VALIDATION REPORT ON POST-REGISTRATION CHANGES (PRCs)

Title and reference number of the project activity	Inner Mongolia Electric Power Transmission and Transformation Chayouzhongqi Wind Farm 49.5MW Project
Process track	<input type="checkbox"/> Prior approval <input checked="" type="checkbox"/> Issuance <input type="checkbox"/> Renewal of crediting period
Version number of the validation report on PRCs	01
Completion date of the validation report on PRCs	29/03/2017
Type(s) of PRCs	<input type="checkbox"/> Temporary deviations from the registered monitoring plan, monitoring methodology or standardized baseline <input type="checkbox"/> Corrections <input type="checkbox"/> Changes to the start date of the crediting period <input type="checkbox"/> Inclusion of a monitoring plan to a registered project activity <input checked="" type="checkbox"/> Permanent changes from registered monitoring plan, monitoring methodology or standardized baseline <input type="checkbox"/> Changes to the project design of a registered project activity <input type="checkbox"/> Types of changes specific to afforestation and reforestation project activities

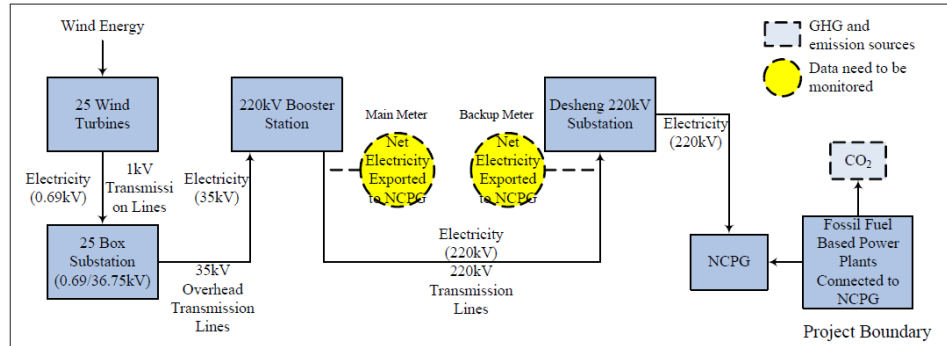
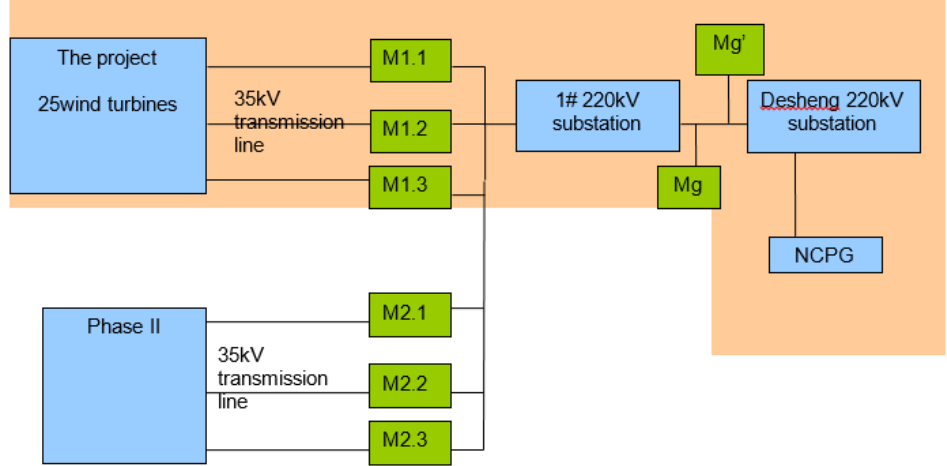
Corresponding to the changes of the monitoring structure, the monitoring for the parameters $EG_{\text{export},y}$ (electricity exported to the grid by the project) and $EG_{\text{import},y}$ (electricity imported from the grid to the project) changed from directly measured by the main meter installed at the 220kV booster station (the meter installed at the Desheng 220kV substation as the backup) to calculated based on the measured values of the meters as below:

Findings	CAR-01: As per the interview with the project owner and verifying the Power Purchase Agreement, the verification team found that the location of the monitoring meters was changed as per the requirement of the power grid company after the subsequent Phase II wind power plant finished the construction and shared the substation of this project. PP is requested to provide the revised PDD which indicates the actual monitoring scheme. (Refer to Appendix 4)
Conclusion	CTI confirms that the post-registration changes comply with the relevant requirements related to the permanent changes from the registered monitoring plan in the Project Standard (Ver. 9.0) and do not require the prior approval by the EB.

<p>monitoring plan (no lower than 0.5s.);</p> <ul style="list-style-type: none"> the calculation of $EG_{\text{export},y}$ and $EG_{\text{import},y}$ is reasonable. <p>The PDD has been revised to indicate the changes from the registered monitoring plan. Through the on-site investigation and the document review, the Verification Team has confirmed that the actual monitoring structure is in accordance with the Power Purchase Agreement /6/ and revised monitoring plan reflects the actual project information.</p> <p>As per the Project Standard (Ver.9.0), for the “Permanent changes from the registered monitoring plan”, if the changes to the monitoring of the registered CDM project activity is related to the one(s) listed below which do not require prior approval by the Board:</p> <p>(a) Change of calibration frequency or practice for monitoring equipment not within the control of project participants or the coordinating/managing entity;</p> <p>(b) Change of accuracy/type/model of meter(s) as per a power purchase agreement (PPA); or</p> <p>(c) Change of location of meter(s) as per a PPA;</p> <p>(d) Change of location of electricity meters if the transmission loss is taken into account;</p> <p>(e) Change of location of substation not within the control of the project participants or the coordinating/managing entity;</p> <p>(f) Change of calibration frequency or practice for monitoring equipment as per the applied methodology or national standard; or</p> <p>(g) Change of frequency of monitoring certain parameters as per the applied methodology.</p> <p>As stated above, the changes of the proposed project are only related to the changes on the quantity and location of the monitoring equipment (i.e. the meters need to be installed at the 35kV transmission lines of each project for cutting the quantity of total electricity of two projects as per the requirement of PPA). It considers the changes belongs to the item (c), thus the proposed changes do not require the prior approval by the EB. CTI confirms that the changes do not affect the application of the applied methodology and do not reduce the level of accuracy of the monitoring compared with the requirements contained in the registered monitoring plan. And also the changes do not lead to a reduction in the accuracy of the calculation of emission reductions.</p>

CAR ID	01	Section no.	D.6	Date: 20/10/2015
Description of CAR				
As per the interview with the project owner and verifying the Power Purchase Agreement, the verification team found that the location of the monitoring meters was changed as per the requirement of the power grid company after the subsequent Phase II wind power plant finished the construction and shared the substation of this project. PP is requested to provide the revised PDD which indicates the actual monitoring scheme.				
Project participant response				Date: 21/03/2017
<i>There are permanent changes of practice for monitoring equipment not within the control of project participants which has been indicated in the Revised PDD.</i>				
Documentation provided by project participant				
<i>Revised PDD (Version 3.0 dated 07/02/2017)</i>				
DOE assessment				Date: 22/03/2017
<i>The Revised PDD has been provided by PP to indicate the permanent changes in the monitoring system. The Verification Team confirms the updated monitoring system is consistent with the actual condition and according to the requirement of the Grid Company. As per the Ver.9.0 of PS, these changes do not need to get the prior approval from EB. Therefore, the Revised PDD will be submitted following the verification documents. CAR 1 is closed.</i>
